**TOWN OF NEWBURGH  
PLANNING BOARD  
TECHNICAL REVIEW COMMENTS**

**PROJECT NAME:** RIVIAN AUTOMOTIVE  
**PROJECT NO.:** 2021-35  
**PROJECT LOCATION:** SECTION 96, BLOCK 1, LOT 6.2  
**REVIEW DATE:** 14 FEBRUARY 2022  
**MEETING DATE:** 17 FEBRUARY 2022  
**PROJECT REPRESENTATIVE:** GPD ENGINEERING & ARCHITECTURE

## Rivian EV Charging Station – Response to Board Comments

**C-111**

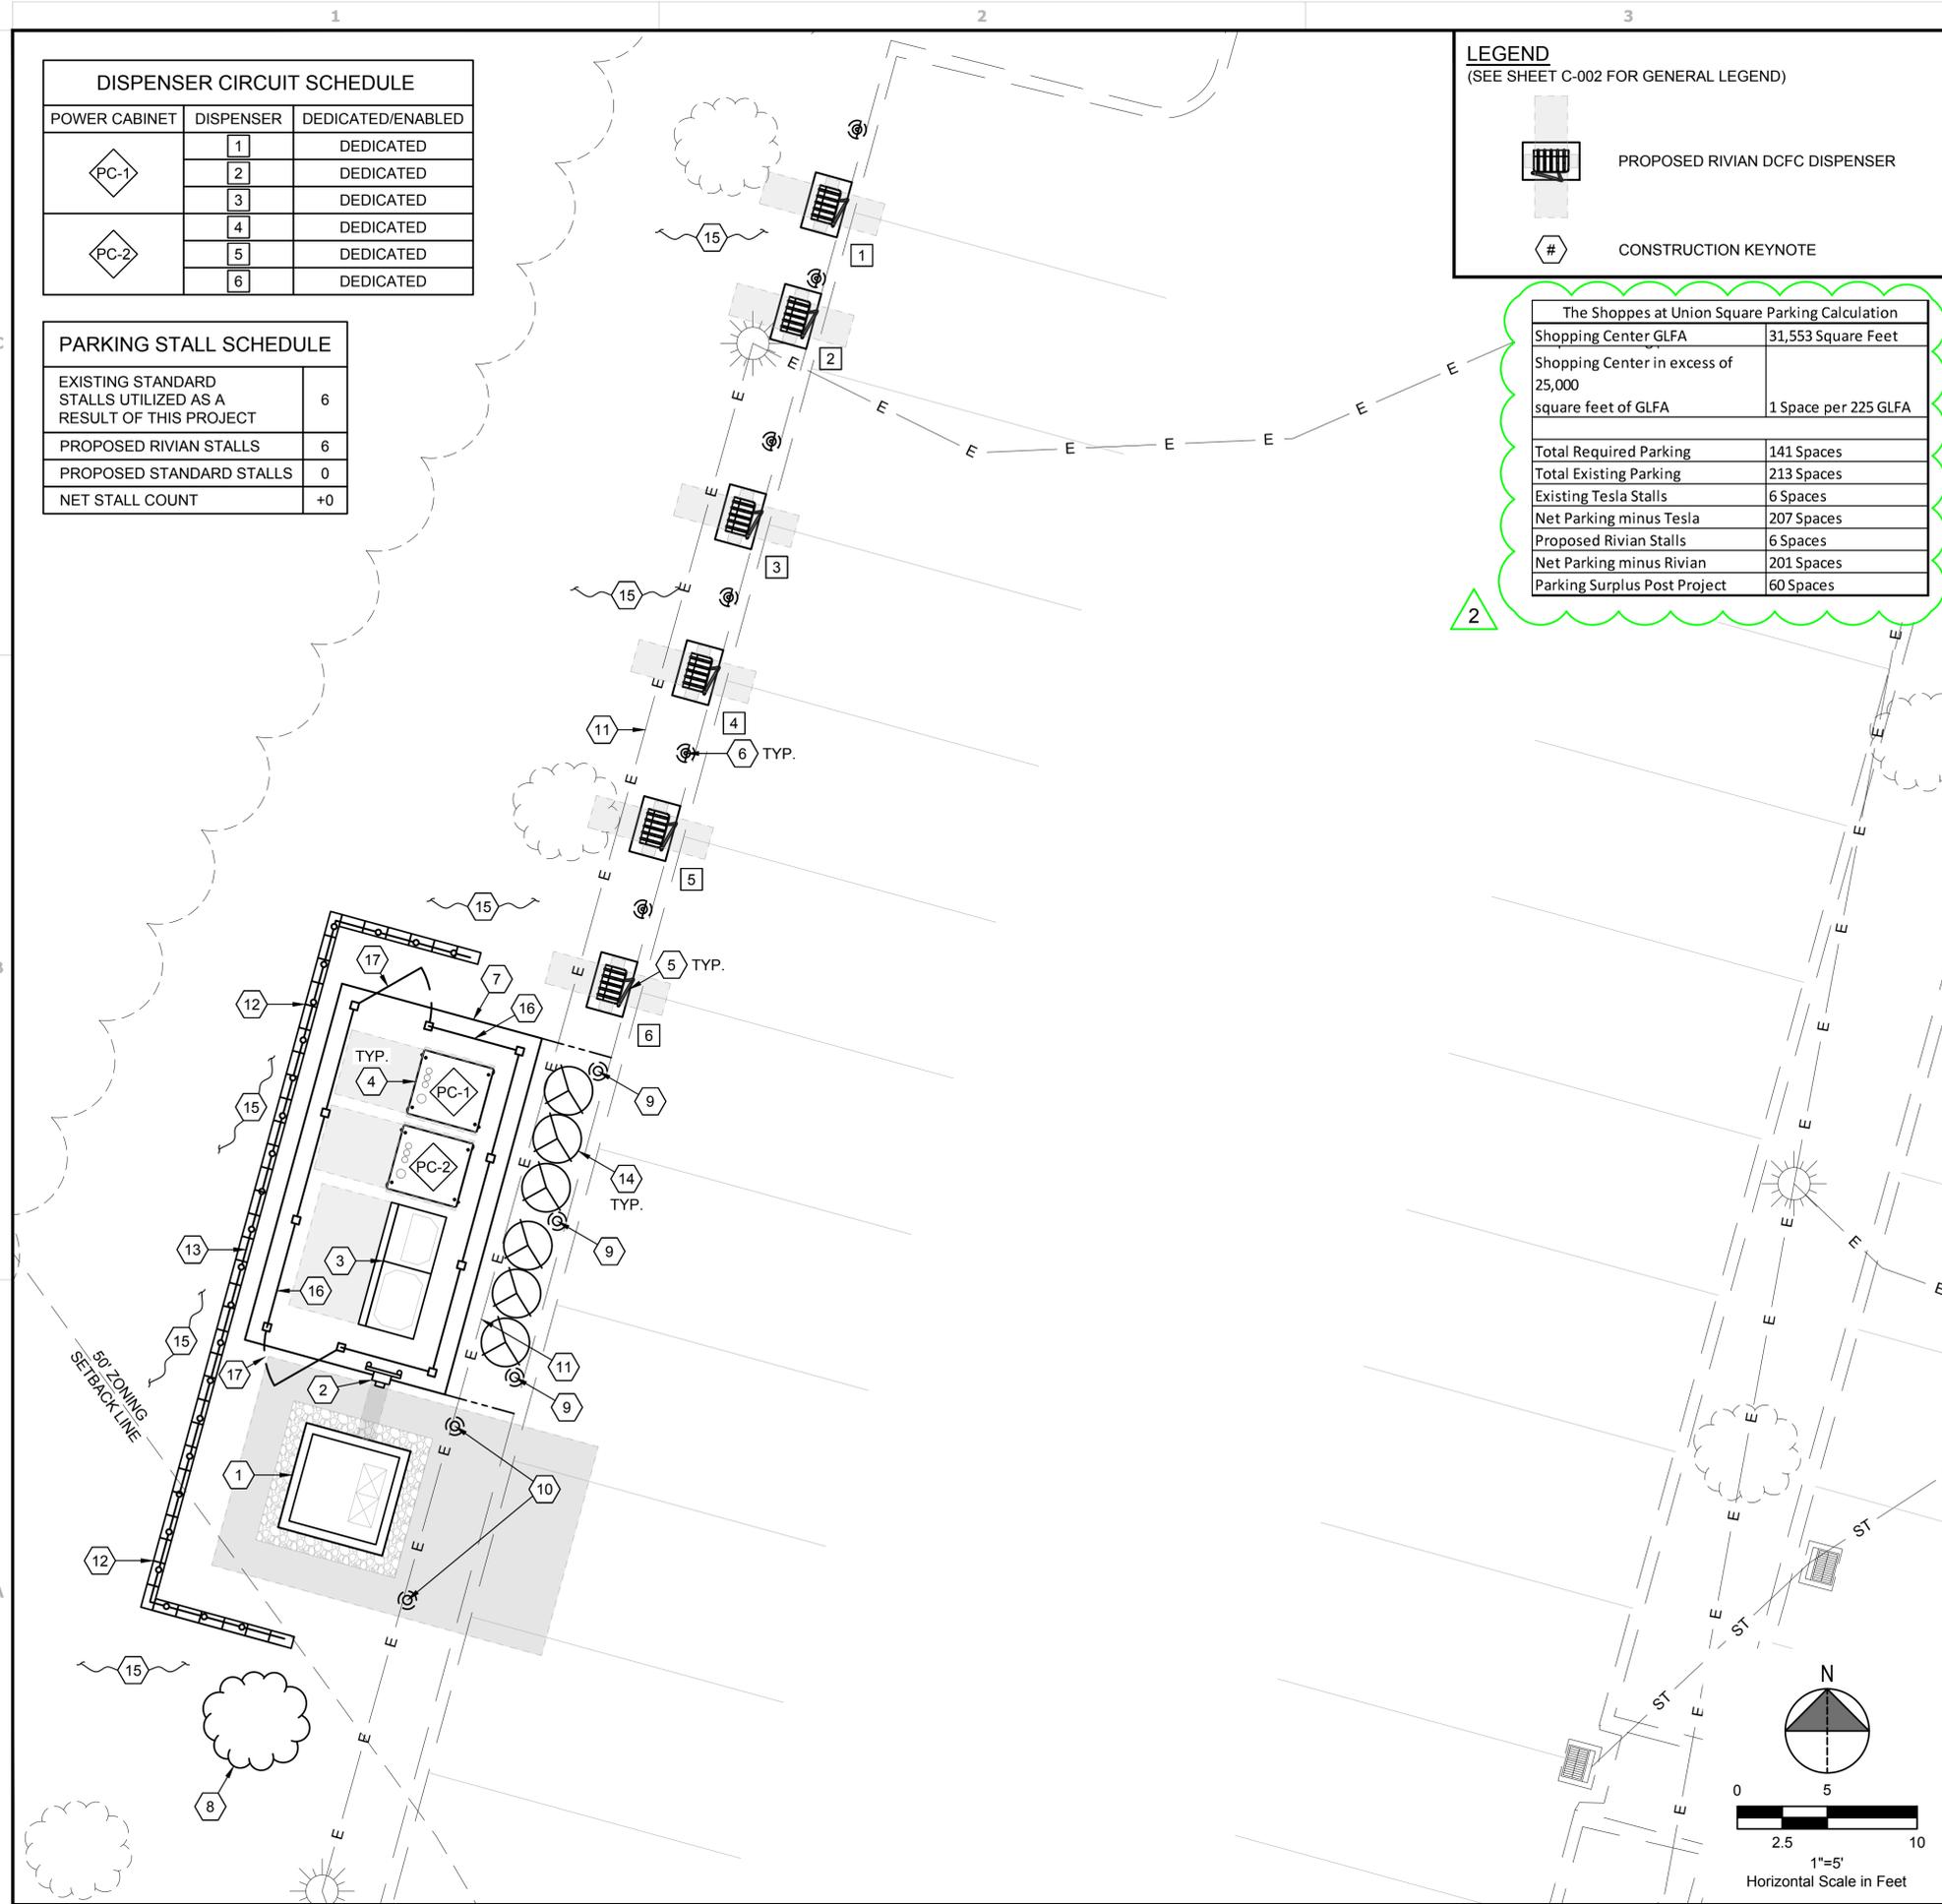
2. The parking analysis should be submitted identifying that sufficient non-electric vehicle charging areas are available based on the use of the site as a shopping center. Currently the site contains designated Tesla charging stations. This application proposes 6 parking spaces designated for electric vehicle charging station.

4. The proposed landscape shrubs to be located in front of the equipment enclosure shall be planted at 36" height.

**Response: A parking analysis table has been included on Sheet C-111. Based on the parking requirements for shopping centers in excess of 25,000 gross leasable floor area, the shopping center currently has a surplus of 60 spaces with both the Tesla and Rivian EV stalls included.**

Response: Per the Board's request, the proposed Viburnum shrubs have been specified to be planted at 36" height as noted on Sheet C-111.

**S-101**

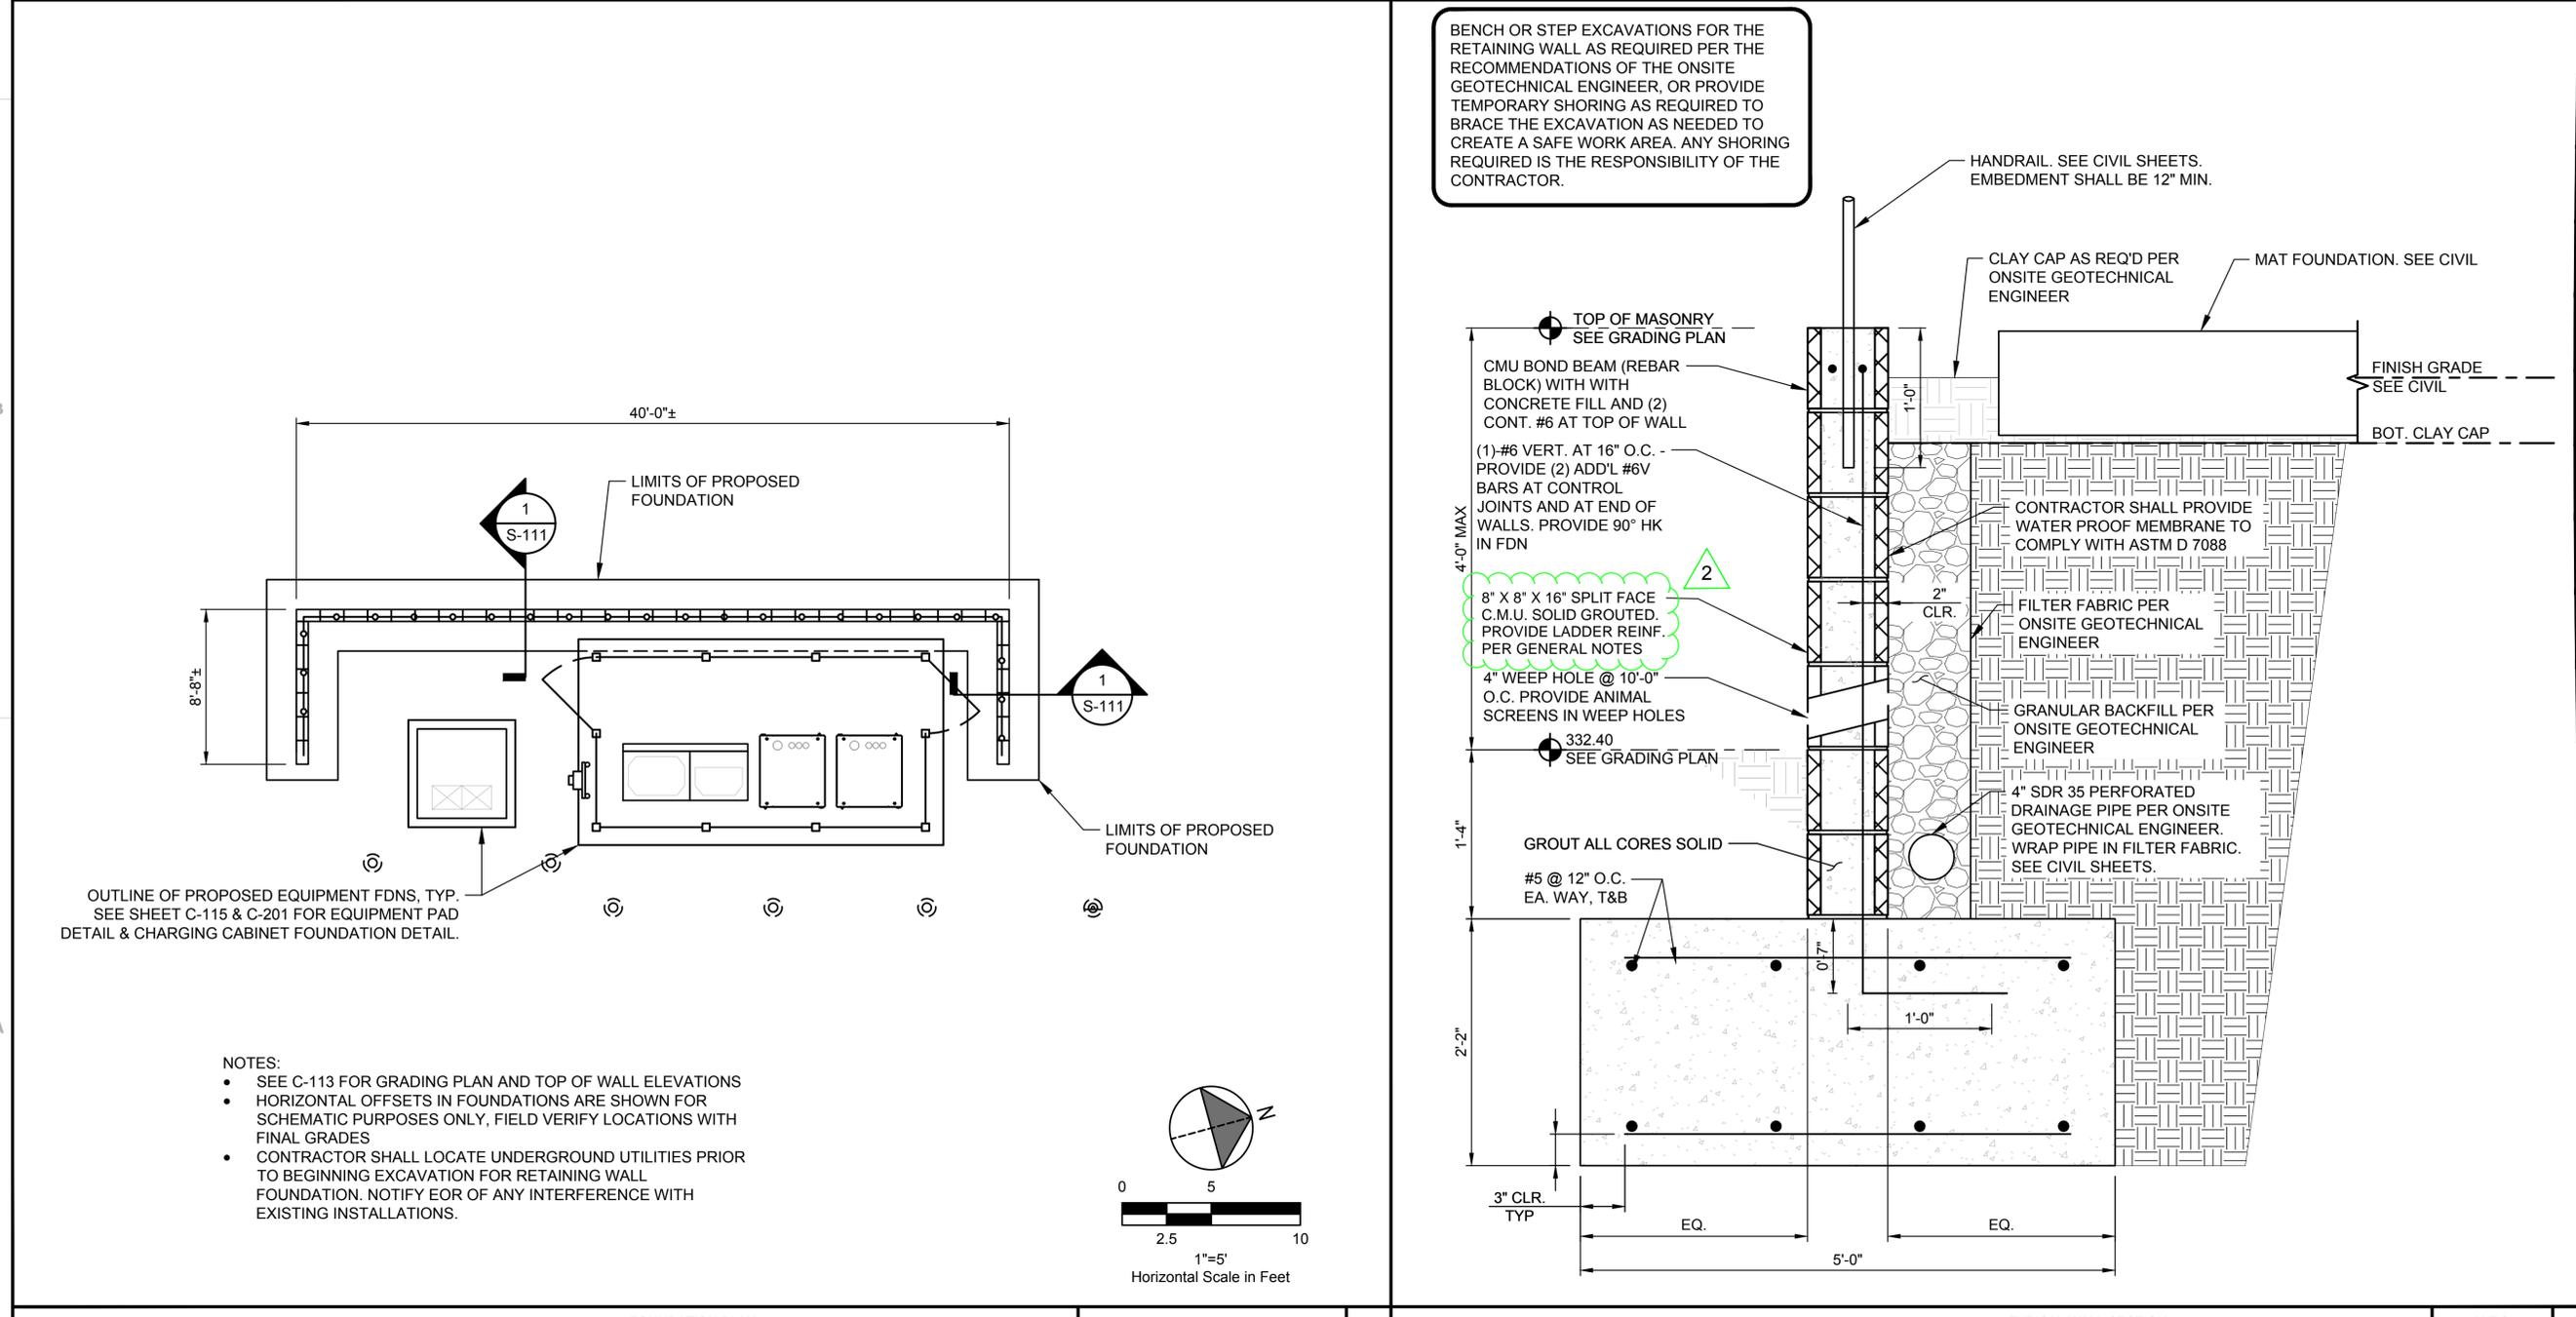
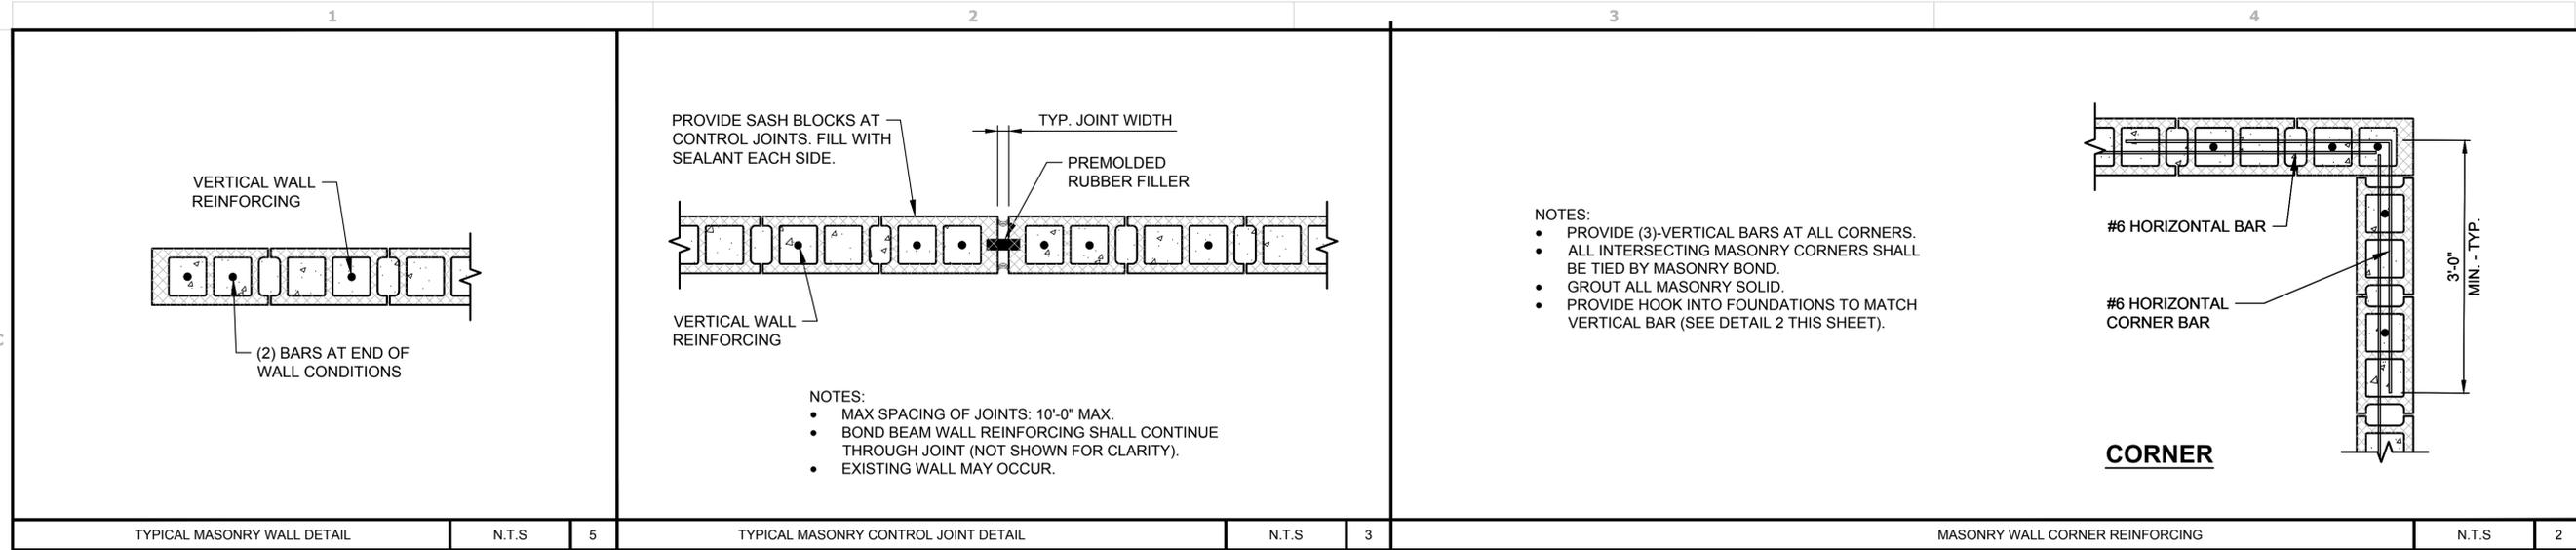
5. The applicant is requested to identify if the type of CMU block utilized for the lower retaining wall will be split faced or if other architectural covered block will be utilized to match existing Site Plan.

Response: Split faced CMU block will be utilized for the lower retaining wall. A photo sample of the proposed block type will be provided as part of the Architectural Review Board. The split faced block as also been specified on the plans on Sheet S-101.
